Project: Gary E. Miller Canadian County

Children's Justice Center Additions

Date: September 7, 2018

Subject: Addendum No. 4

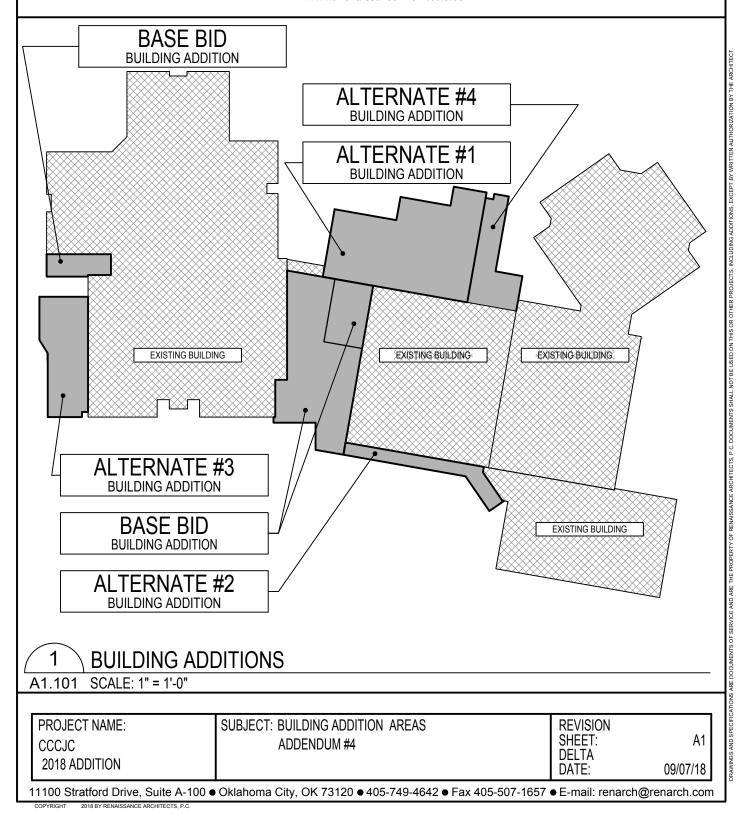
**Clarification:** The attached key plan (Sheet A1) is a quick reference plan that shows the locations of the base bid and alternate areas. Refer to Base Bid Set Sheet A1.101 for more alternate location and site information.

**Clarification:** Sheet A1.101 does not indicate the location of Alternate #4. Refer to attached key plan (Sheet A1) for reference to location of Alternate #4.

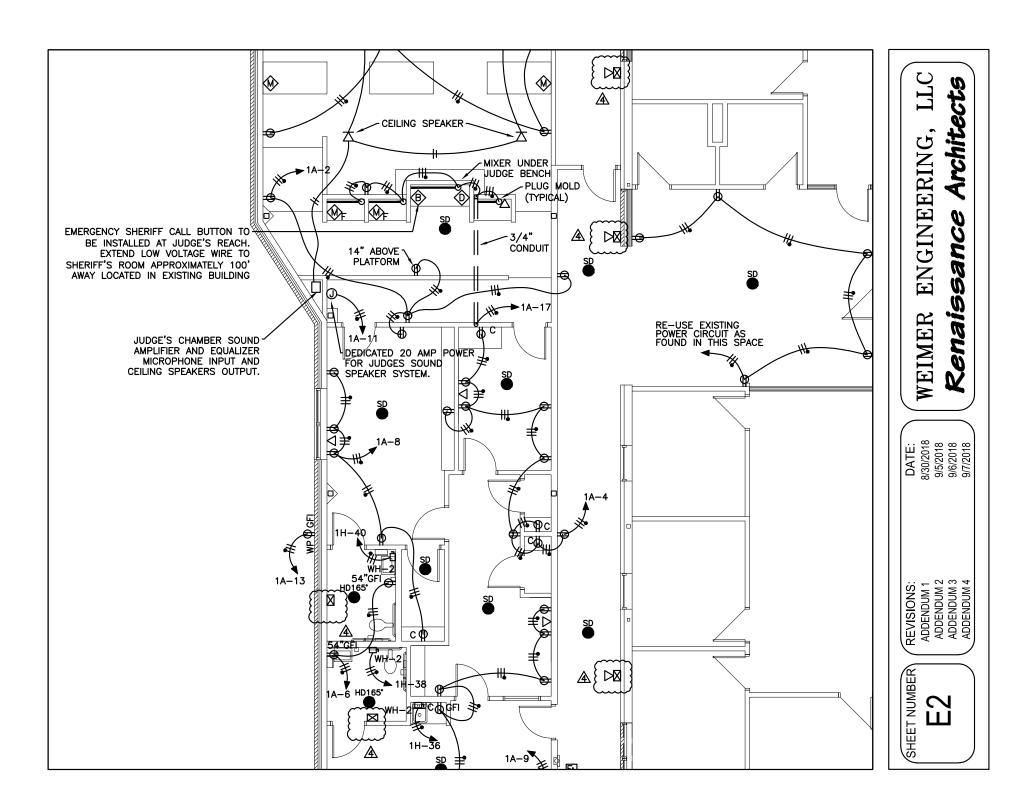
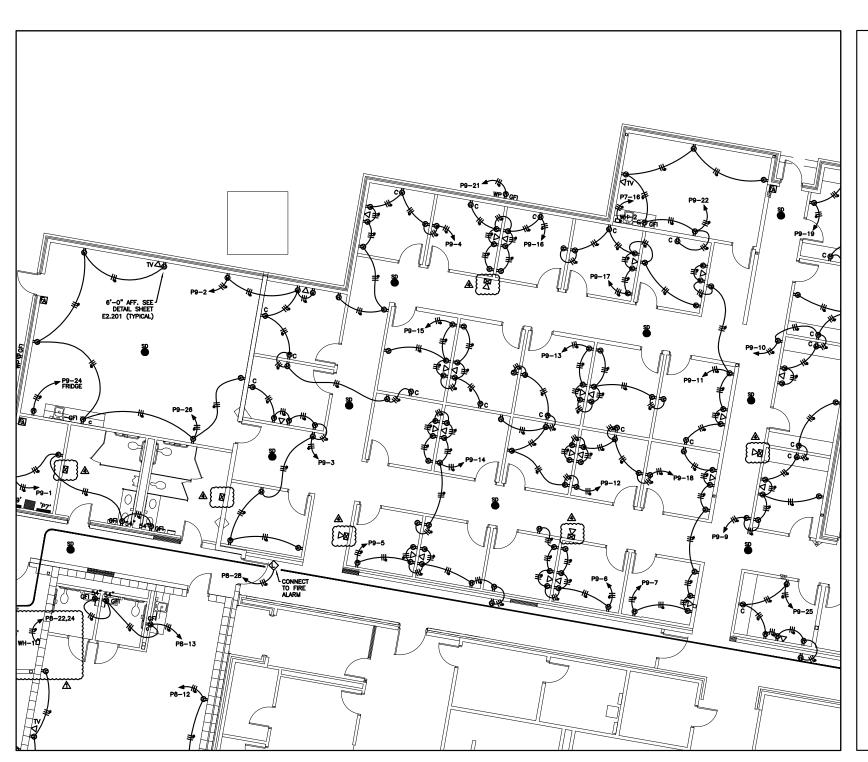
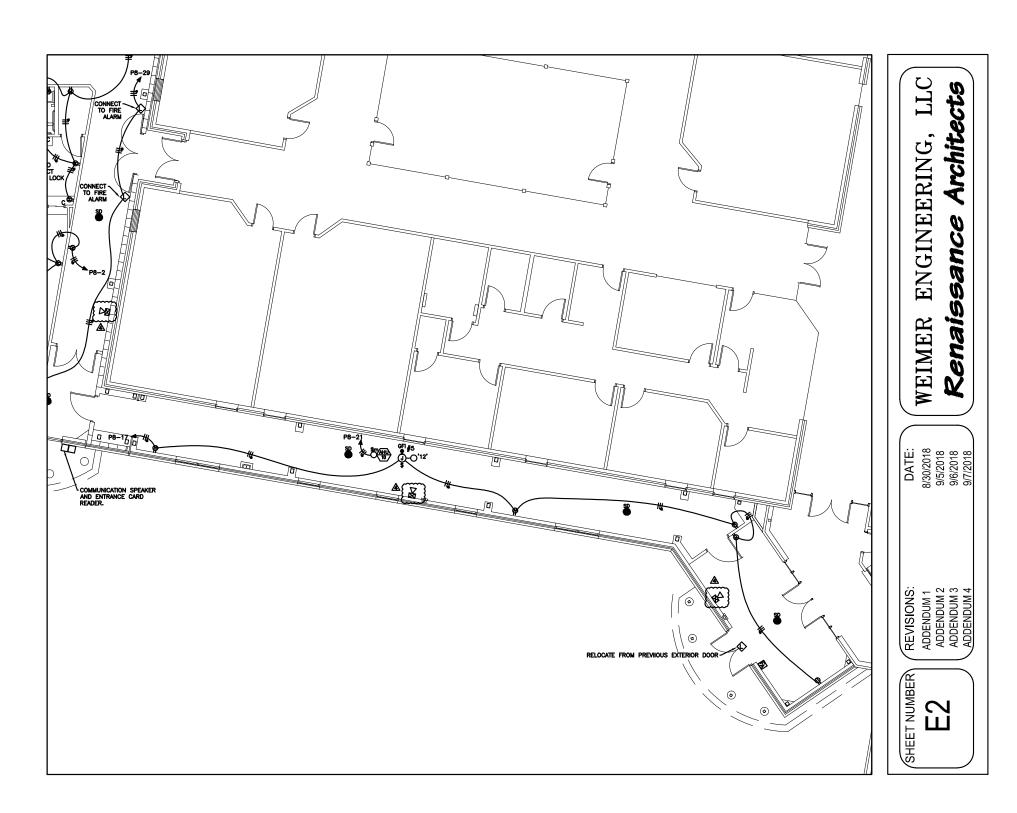
**Add:** Fire annunciation equipment to be added in all newly created spaces as per code. This shall include horns, strobe lighting and horn/strobe combinations. These items are to be added onto the existing fire alarm system. Drawings had already included detection equipment of pull stations and smoke detectors. Refer to attached addendum sheets E2 (four pages) for proposed scope of annunciation equipment.
